Attachment 1 to Initial Comments of the Clean Energy Organizations

A Clean Energy Alternative for Otter Tail Power

September 2023

Energy Futures Group and Applied Economics Clinic were asked to conduct an independent technical review of Otter Tail Power's Supplemental Integrated Resource Plan ("IRP"), making corrections, as deemed appropriate in our professional opinions, to Otter Tail Power's EnCompass modeling assumptions, and exploring alternative combinations of unit retirements and additions that would better fit the policy preferences outlined in Commission orders and state statutes.

Figure 1: New Wind Costs (levelized nominal \$/MWh)

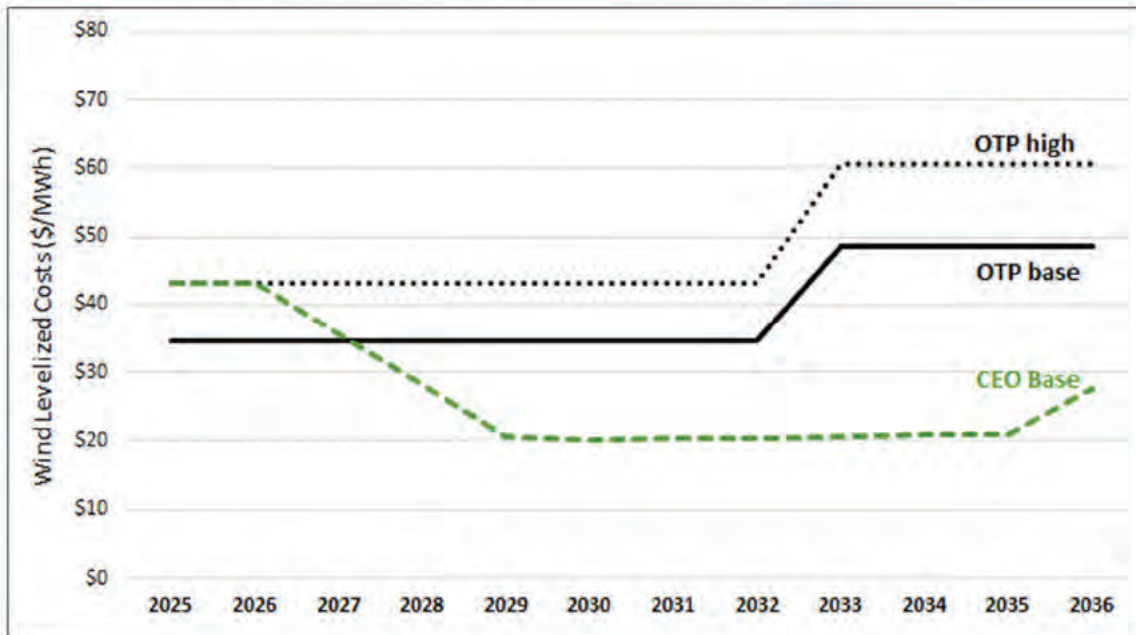
The resulting new resource costs, shown below, match OTP's high costs for 2025 and 2026 and then costs re-balance between 2027 and 2029 to meet the long-term cost trajectories from NREL; all costs incorporate corrections to the IRA tax credits. With these changes, our costs are higher than OTP's base case in at least the short-term—or as late as 2032 in the case of solar PV—and substantially lower than OTP's wind and four-hour battery storage costs in the medium to long-term.

Figure 5. Cumulative Installed Capacity (MW) Between 2027 and 2050

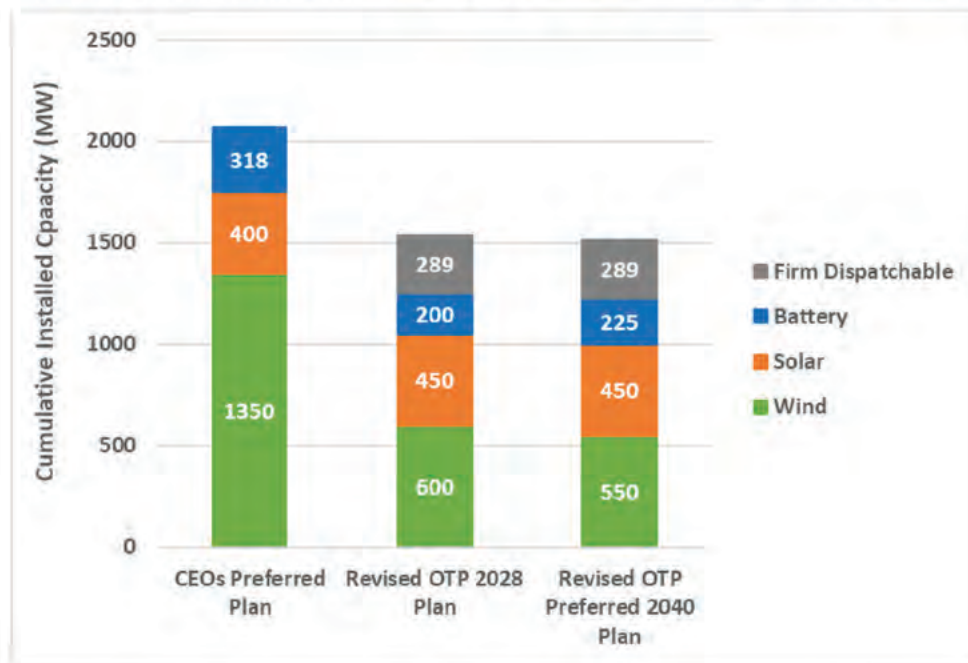
Figure 5 shows a comparison of the cumulative installed capacity in MWs from 2027 to 2050 for the CEOs Preferred Plan, the Revised OTP Preferred 2040 Plan, and the Revised OTP 2028 Plan. The main differences in the resource additions in the three plans are:

- (1) The CEOs Preferred Plan includes an additional 150 MW of replacement wind for the Coyote withdrawal in 2028;
- (2) The CEOs Preferred Plan includes 300 MW of additional generic wind resources in 2029;
- (3) The CEOs Preferred Plan includes the withdrawal from Big Stone in 2030 and replacement resources consisting of 150 MW of 4-hour battery storage and 100 MW of wind. The Revised OTP 2028 Plan and the Revised OTP Preferred 2040 Plan continue to operate Big Stone until 2046 and then the model selects the “firm dispatchable”²⁵ resource after Big Stone retires.

Figure 6. Annual Carbon Emission Comparison for OTP Thermal Resources in Each Plan (Tons)

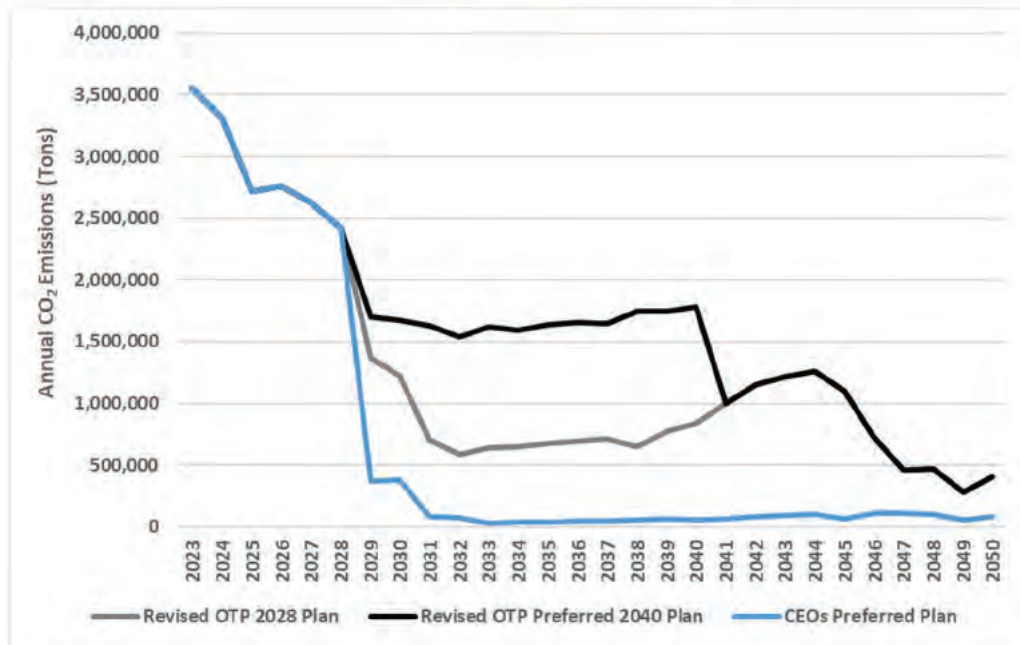
The level of carbon emissions reduction between the CEOs Preferred Plan and the two Otter Tail plans is another important factor to consider when evaluating them. **Error! Reference source not found.** provides the cumulative CO₂ emissions comparison between the three plans when only considering the emissions from OTP's existing and planned resources in the portfolio over the planning period (2023-2050). Table 14 also includes the cumulative emissions for each portfolio between (2023-2030) and (2031-2040) to show the emissions impact for each decade. Table 14 does not reflect the additional carbon emissions associated with MISO purchases, and our modeling shows these emissions would be much higher under either of OTP's plans than under the CEOs Preferred Plan. **Error! Reference source not found.** shows the annual carbon emissions comparison between the plans when considering emissions from OTP's thermal resources.
